Document Title		Addition of Bushing to Platen Plate				
Document #	Rev	Type	Reason	Recommendation	Original Release Date	
ZSB-029	Original	Service Bulletin	Reliability / Safety	Optional / Mandatory	November 10,2021

Addition of Bushing to Platen Plate
Applies to units produced prior to Oct. 2020

Purpose: The purpose of this service bulletin is to advise customers of a product improvement related to the operation and adjustability of the Rotatub Slip Clutch.

Figure 2 Top Plate Attachment Fasteners

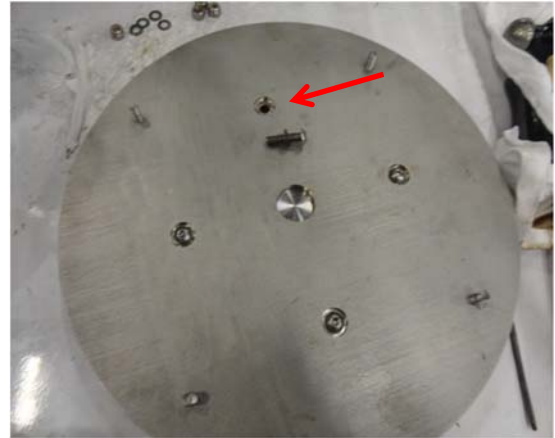
2. Using a 7/16 Box wrench and a 5/32 hex key remove the 1/4-28 bolts (4), being careful to note the position and orientation of the Belleville washers. *See figure 2*

Figure 3 Bronze Plate and Flat Head Screws

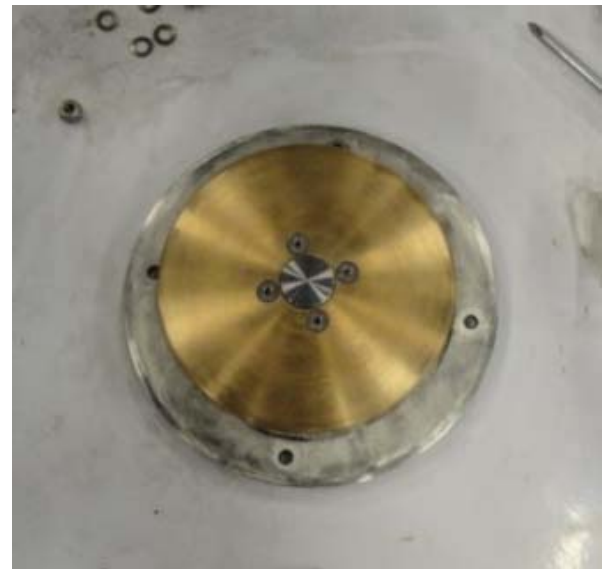
3. Remove the top plate and clean all the grease or remove the slip pads from the upper plate.
4. Remove the (4) Flat head screws that attach the bronze disc to the axel shaft, in order to remove the bronze disc. Use of an impact tool may be required. *See figure 3*

Figure 5 Torque Watch 0-24 in-oz

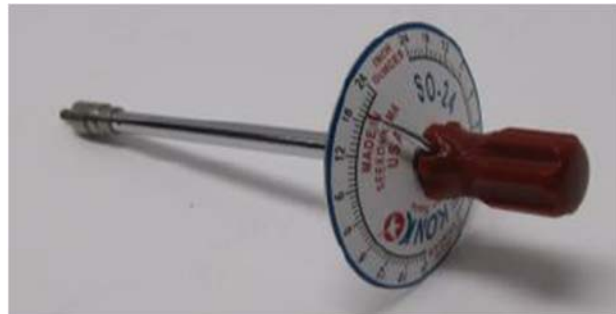
Procedure: The Infinitely Adjustable platen assembly ZGS-10248-1 must be disassembled. The Top Plate ZGS-10180-2 must be replaced or reworked to add the bushing ZGS-10886-1. The slip pads should also be replaced. The adjustment of the revised assembly requires the use of a Torque Watch, see figure 5.

12. Tighten the screws evenly to obtain 6 in-oz on each screw. This requires holding the nut on the bottom of the screw with the 7/16 hex wrench and tightening the screw with a 5/32 hex key. Then measuring the residual torque to spin the screw using the torque watch, see figure 6. Do not apply torque to tighten the screw with the torque watch.
